Errata to MPC8533E PowerQUICC™ III Integrated Host Processor Family Reference Manual, Rev. 1

This errata describes corrections to the *MPC8533E PowerQUICC™ III Integrated Host Processor Family Reference Manual*, Revision 1. For convenience, the section number and page number of the errata item in the reference manual are provided. Items in bold are new since the last revision of this document.

Figure 19-12. Device Disable Register (DEVDISR)

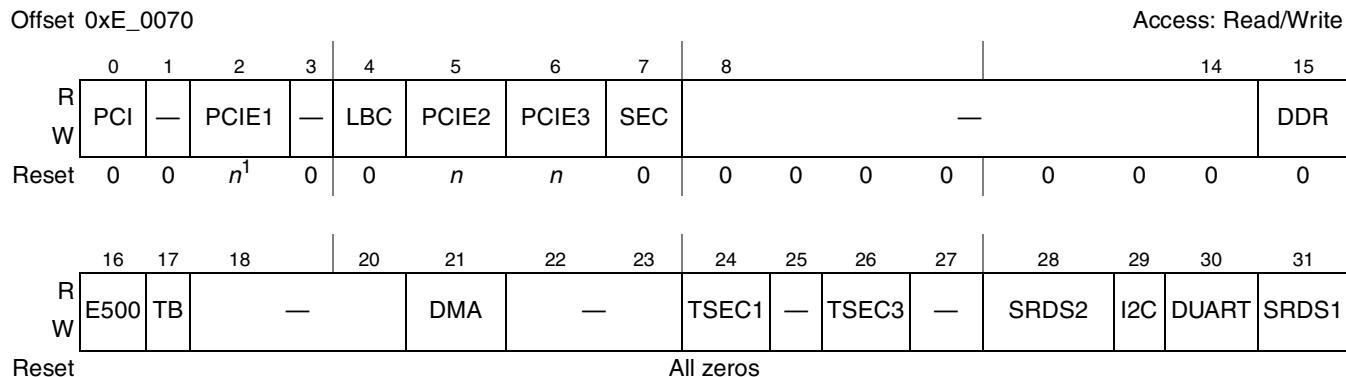
19.4.1.12, 19-14 Added fields SRDS2 and SRDS1 (bits 28 and 31) to Figure 19-12, “Device Disable Register (DEVDISR)” and Table 9-15, “DEVDISR Field Descriptions.” The register figure and field description table changes should appear as follows:
